UNITED STATES PATENT AND TRADEMARK OFFICE

APPLICATION NO.	FILING DATE	FIRST NAMED INVENTOR	ATTORNEY DOCKET NO.	CONFIRMATION NO.
10/674,198	09/29/2003	James Patrick Clinch	140/40652/O&T 975	2676
279	7590	07/15/2005	EXAMINER	
TREXLER, BUSHNELL, GIANGIORGI, BLACKSTONE & MARR, LTD. 105 WEST ADAMS STREET SUITE 3600 CHICAGO, IL 60603			MITCHELL, KATHERINE W	
			ART UNIT	PAPER NUMBER
			3677

Office Action Summary

DETAILED ACTION

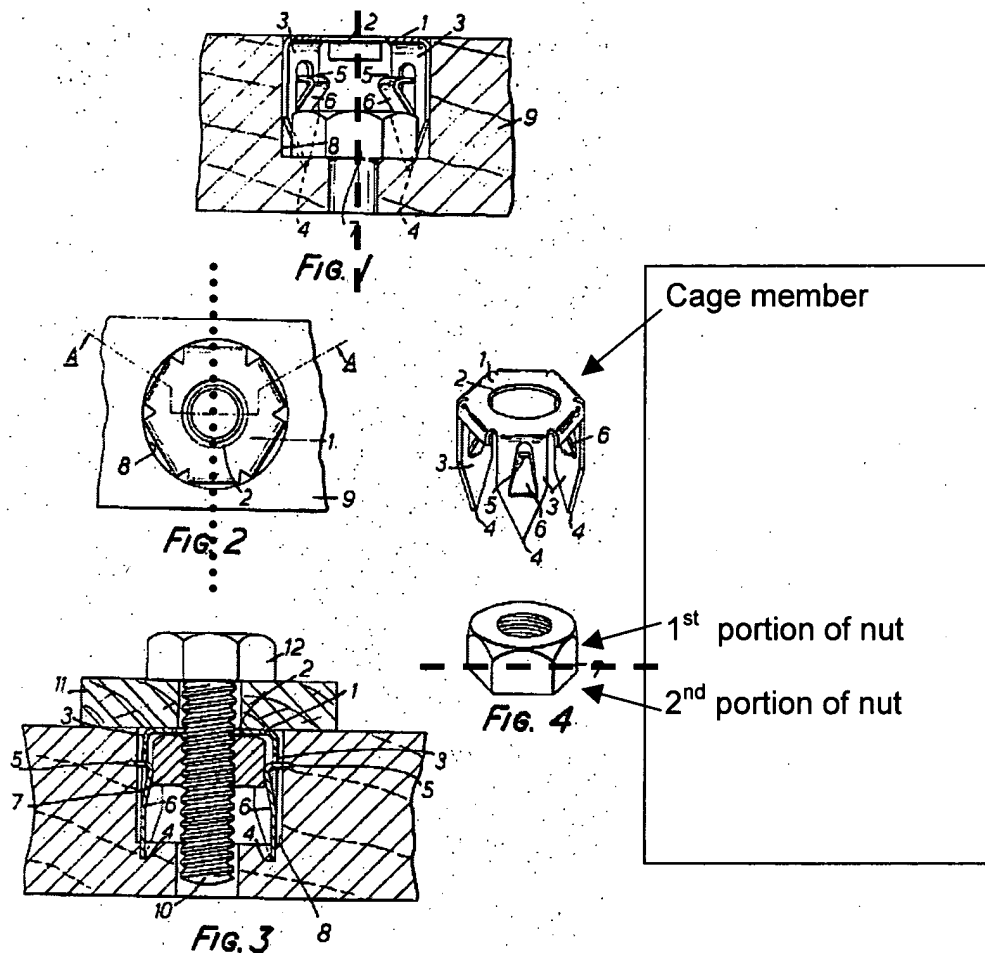
9. Claims 1-3,5-8,10-12,14-15, 19-20, are rejected under 35 U.S.C. 102(b) as being anticipated by Parkin USP 3451455.

Re claims 1 and 10: Parkin teaches a cage member (upper item in Fig 4) engageable with nut 7 having first and second portions and an aperture extending at least partially therethrough, (note that applicant is not claiming the nut, and a nut is capable of having distinct first and second portions. **However, further regarding claim 10**, the nut of Parkin can be considered to have a 1st portion [upper section in the figures, having the tapered sides] and a 2nd portion [lower section without taper]) thereby providing a cage nut assembly, said cage member comprising:

A body configured to encage the nut and having an aperture configured to allow access to the aperture of the nut member when the nut is encaged by cage member,

Said body defining a base portion (1) and at least one wall portion (3) and configured to engage the nut first portion such that the nut second portion does not come into contact with either the base or said at least one wall (Fig 1- notice that neither portion of the nut contacts the base or at least one wall, and in Fig 3, the 2nd portion does not contact the base or a wall 3), said body provides a limited range of nut movement in at least one dimension (axially along what could be called the bolt axis - see dashed line by examiner in Fig 1 above, although there is slight radial movement

also), said body configured to allow access to nut member aperture within the limited range of movement of the nut member.

Re claims 2-3, 5, 11-12,14: Said upper portion comprises at least one arm (6). Looking at Fig 2, note that there are at least two arm portions (6) which are positioned on opposite sides of a plane that bisects the base (see Fig 2 and examiner-drawn dotted line for plane), thus they are positioned opposite one another. The arms define an opening sized to receive the nut member therethrough when the nut 1st portion is engaged by said 2 arm portions (See Fig 3). Examiner notes that applicant did not require the arm to extend **directly** from said base.

Re claims 6,15: Fig 1 shows each arm 6 with a generally "C" shaped portion, and forming an opening between opposite arms.

Re claims 7,19: Looking at the difference in arm 6 between Fig 1 and Fig 3, it is clear that it is inherently flexible.

Re claims 8,20: As best understood, at least one arm portion can be moved (see Fig 1 and 3 comparison of arm for movement) to allow the 2nd portion of the nut member to be positioned above said base (entire nut is always above said base). Nut is between at least one wall portion of said body and something - an opposite wall.

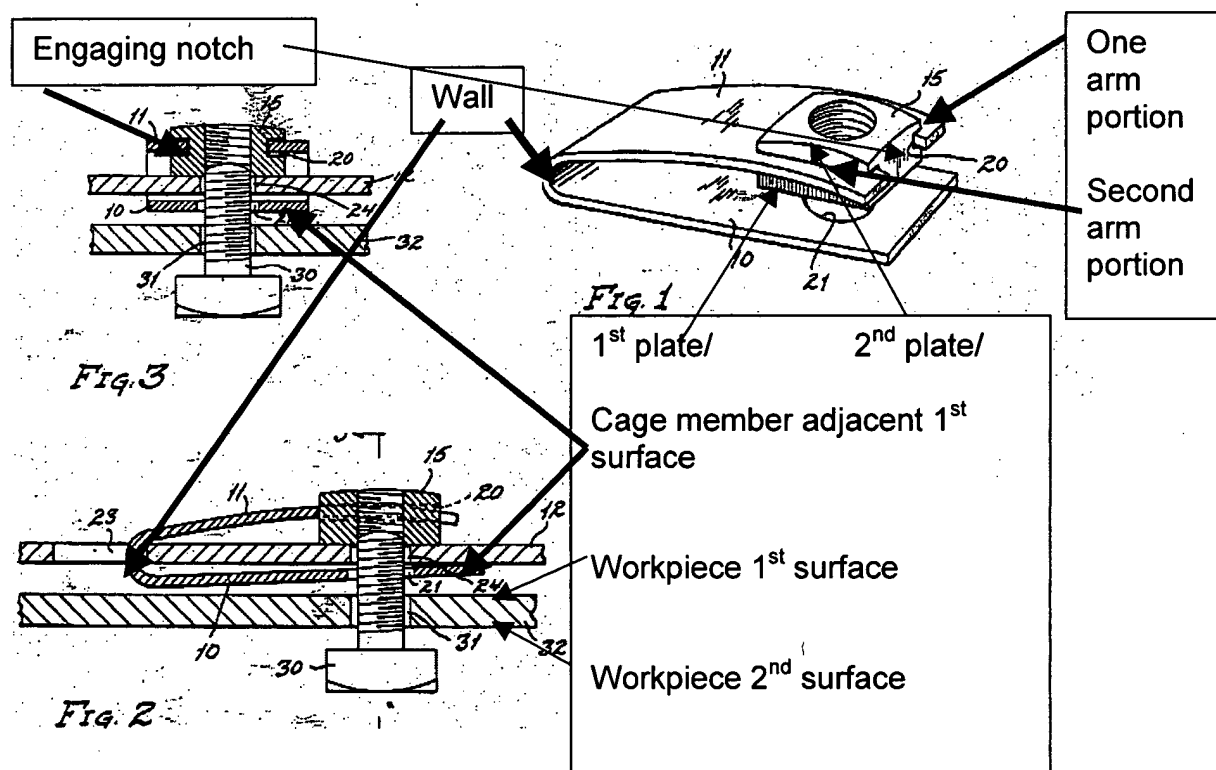
10. Claims 1,-3,7-8,10-12,19, 20, 22, 24, 28, and 29-42 are rejected under 35 U.S.C. 102(b) as being anticipated by Tinnerman USP 2258342, hereafter called Tinnerman '342.

Re claims 1,2,3, 7,8,10,11,12,19,20: Tinnerman 342 in Figs 1-3 teaches a cage member and nut assembly, said nut (15) having a 1st and 2nd portion (see marked up

drawings below) enclosed by a cage member (10/11) which has a body configured to engage the nut member such that the nut member is encaged. The cage further comprises a body (11/10), and "11" is considered the upper cage/arm portion, and "10" is the base. The wall is labeled by examiner in drawings below. The nut engagement is such that the 2nd portion (same as the portion labeled "1st plate" below - looking at the drawings as oriented, it is the "lower" part of nut below "11") of the nut does not come into contact with either the base or the wall. Figs 1 and 3 shows a limited range of motion in at least one dimension. The body provides a limited range of nut movement in at least one dimension (axially along what could be called the bolt axis - although there is slight radial movement also).

Further Re claims 3 and 12: As shown in Fig 1, arm portion 11 forms two arm portions at the end as labeled by examiner in drawings below. These two arms are opposite each other.

Further Re claims 7 and 19: The at least one arm 11 is inherently flexible - see col 1 lines 41-42 and line 27, and line 36 - sheet metal that can be bent is inherently flexible.

Further Re claims 8 and 20: As best understood by examiner, the at least one arm 11 can be moved to allow nut 2nd portion to be positioned over base and between the wall and something - in this case the very end extension of the arm 11 past the notch.

Re claims 22 and 29-30 and 34-35 and 39-42: Tinnerman '342 in Figs. 1-3 teaches a nut (15) enclosed by a cage member (10/11) which has a body configured to engage the nut member such that the nut member is encaged. (Fig 1 and 2) "11" is considered the upper cage portion, and engaging notch (best shown in Fig 1 and 3) will inherently serve to suspend the nut off the base.

Further, the upper portion (arm 11) of said cage member is configured to engage said nut member 15 and is configured to be flexed downwardly by said nut member toward said base portion 10 in order to allow said nut member to contact said base portion (Fig 2). Examiner notes that applicant did not claim direct contact, and it is in contact via contact with intermediate member 12. Fig 2 shows the combination including

Re claim 32,37: The body further comprises at least one wall (see label by examiner above), and Figs 1- 3 show the nut engaged such that the nut does not contact at least one wall.
